**AMENDMENTS TO THE DRAWINGS:**

Figure 17 is amended as described below by presenting replacement figure as attached hereto. An annotated sheet is also submitted for ease of review of the amendments made to Figure 17.

Figure 17

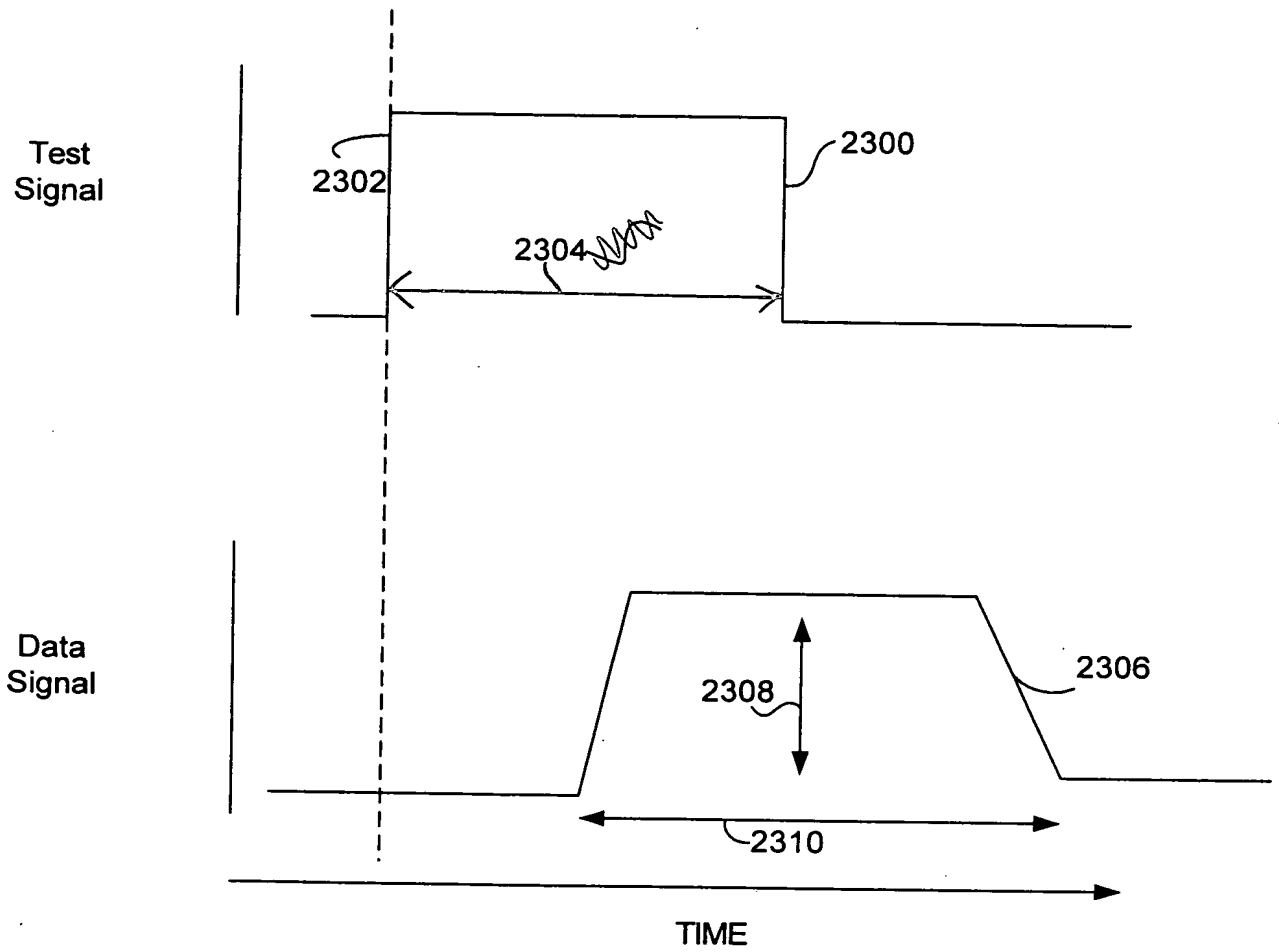
In the Replacement Sheet of Figure 17, element number 2304 has been modified to illustrate a duration of a diagnostic test signal 2300 through a communication channel, as described, for instance, on page 30, paragraph [00132] of the Specification of the present application. No new matter has been added.
